AGENDA Village of Chenequa Monday, April 14, 2025 31275 W County Road K, Chenequa, WI 53029

To: Plan Commission, Village of Chenequa

Subject: Site Plan Review

Project Description: Primary Residence and Landscape Plan

EXISTING TOPOGRAPHIC SURVEY FOR: ZIEGLER FAMILY OFFICE INC. PART OF THE NW 1/4 OF THE NW 1/4 OF SEC. 28, T8N, R18E VILLAGE OF CHENEQUA, WAUKESHA COUNTY, WI

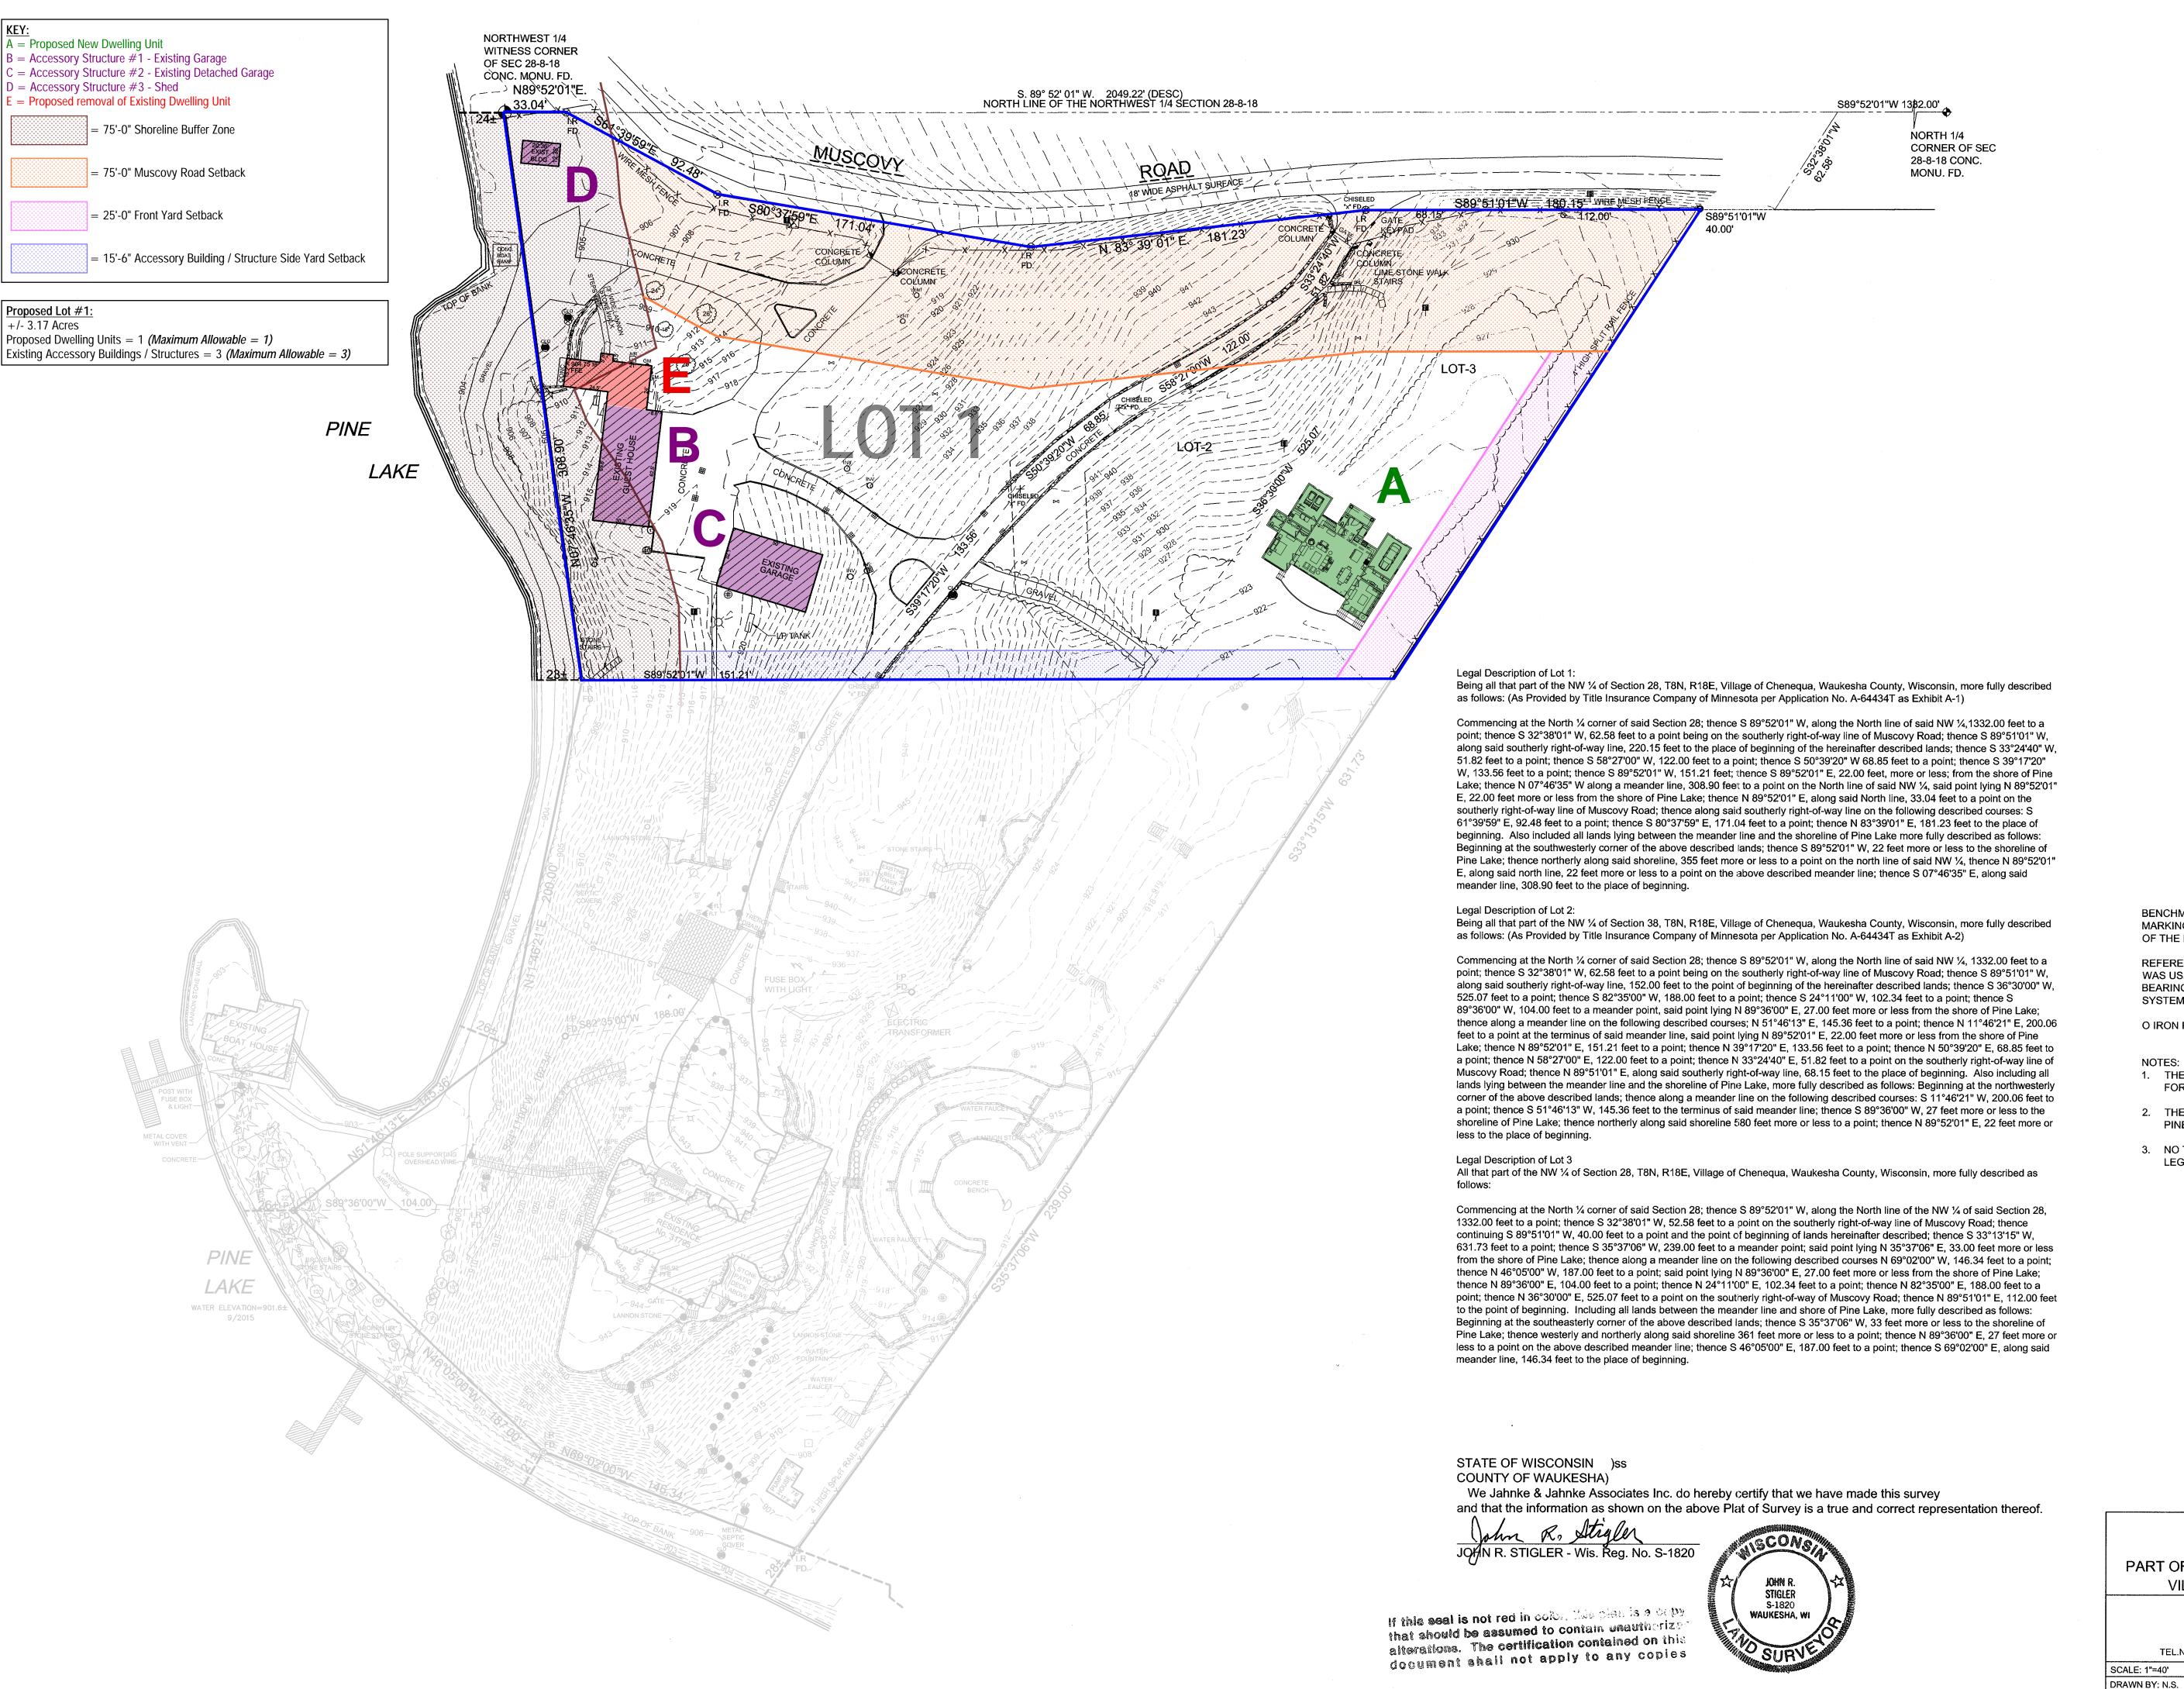
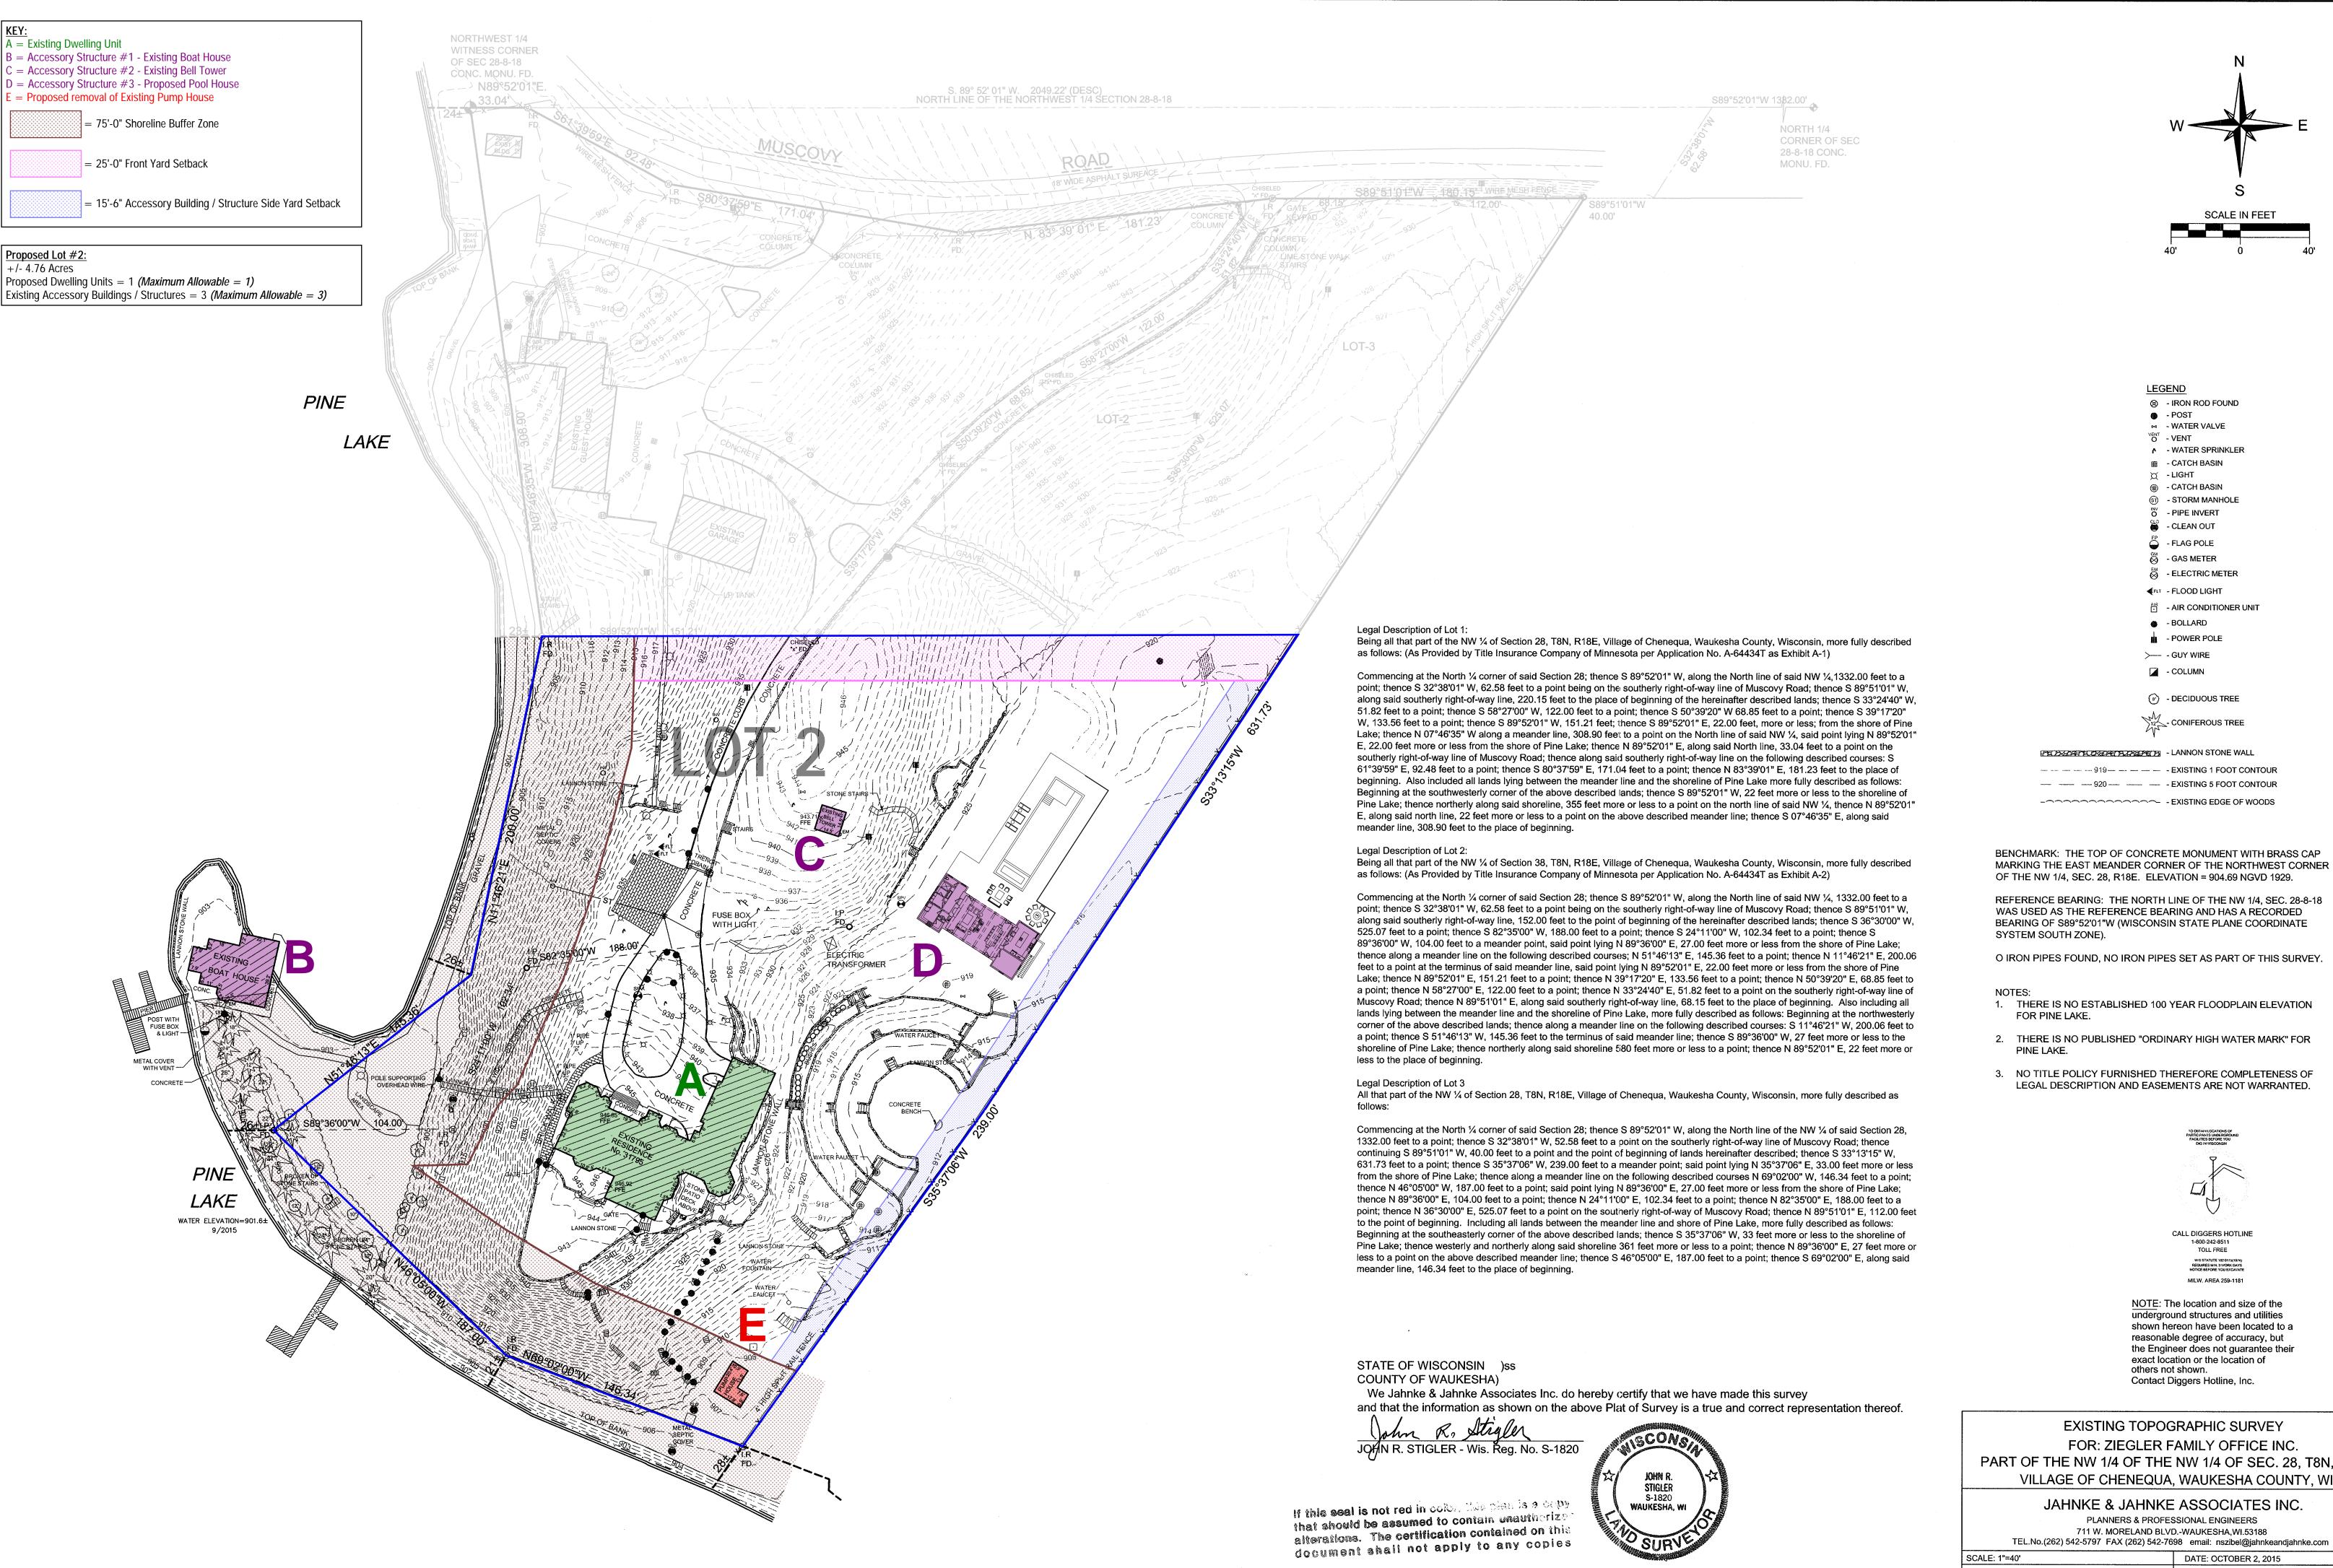
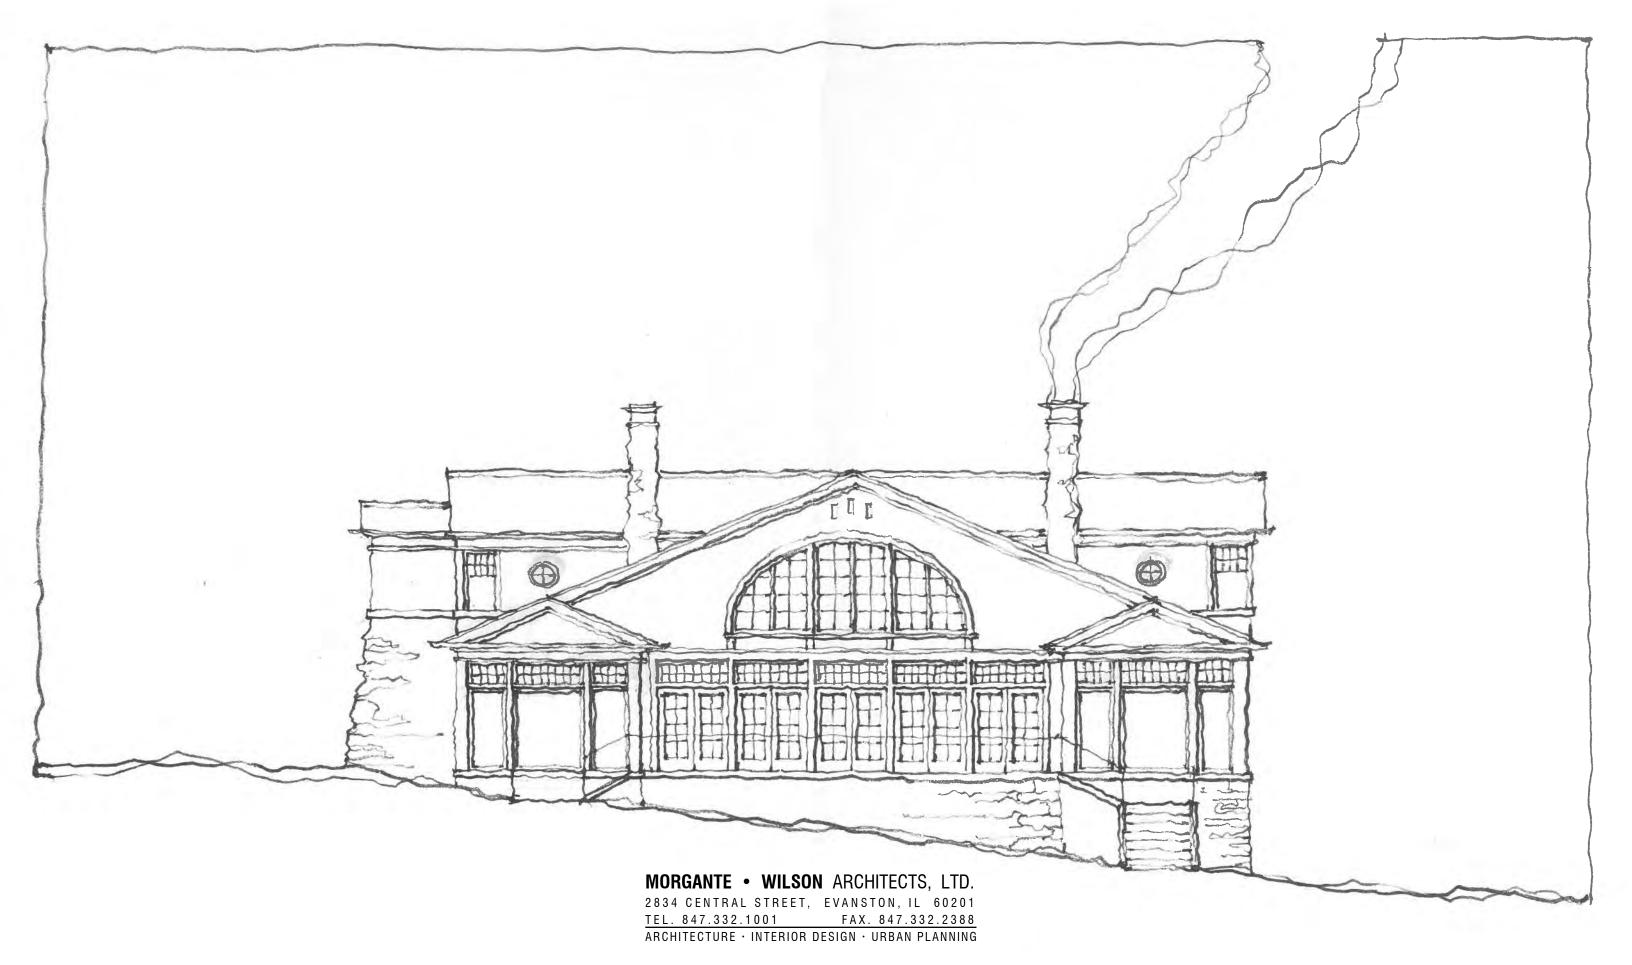
On behalf of the applicants, Morgante-Wilson has submitted a preliminary plan for 31795 W Muscovy Road. The key details of this plan are detailed in a letter drafted by Morgante-Wilson dated March 14th 2025. Please take a moment to review this letter and the requests made by the property owner.

Once the land split has been completed, the applicant will be seeking approval to modify the secondary dwelling on the property (primary dwelling after the split). Currently this dwelling is non-conforming because it is a.) Within the 75' shoreland setback of Pine Lake and b.) the second dwelling on the property. As written in the letter by Morgante-Wilson, the applicant will be seeking permission to remove the "apartment" or dwelling portion of the garage structure to repurpose it as a stand-alone accessory structure.

As noted by Morgante-Wilson; ordinance NO. 2025 6.5(6)(a)(i) of the newly adopted accessory structure ordinance NO. 2025 notes that "No accessory building shall be erected, modified or moved on any lot abutting a lake so that it is located between the shoreline buffer zone and the nearest point of the principal structure or any projection thereof....".

On a side note; this new language contradicts 6.7(4)(c) which states "In addition, a legal nonconforming structure which is nonconforming solely because it is located in part within the shoreline buffer zone and because portions of it are seventy-five (75) feet or less from the ordinary high-water mark of any navigable water, lake, pond, flowage, river or stream may be modified to increase either its footprint, living area or height where all modifications and all changes constituting either a building or structure alteration or reconstruction take place outside of the shoreline buffer zone or more than seventy-five (75) feet from the ordinary high water mark. No such modification shall expand the nonconformity within the shoreline buffer zone".

Once the land division is completed and the "apartment" of the existing accessory structure is removed. Newly created "Lot 1" may have a new primary dwelling constructed. The applicants are seeking permission to place the new primary dwelling behind the three existing accessory structures on the lot. The new primary dwelling would likely be greater than 300' from Pine Lake, situated on the east side of lot 1 (as shown on site plan). A full zoning review of this primary dwelling will be completed when plans are formally submitted.

On proposed "Lot 2". The applicants will be submitting plans for a new pool and pool house structure. As illustrated on preliminary drawings, the new proposed pool and pool house will be placed NE of the primary dwelling (between the house and the road). For the pool and pool house, all requirements of chapters 5 and 6 are applicable and will be reviewed with the final plans.

Including the pool and pool house, proposed "Lot 2" will have <u>four</u> accessory structures. Per 6.5(6)(d) a property that has between 2.5 and 7 acres may only have a total of <u>three</u> accessory structures. The applicants propose to remove the legal-nonconforming pump house on the property in order to allow for the new pool house structure.
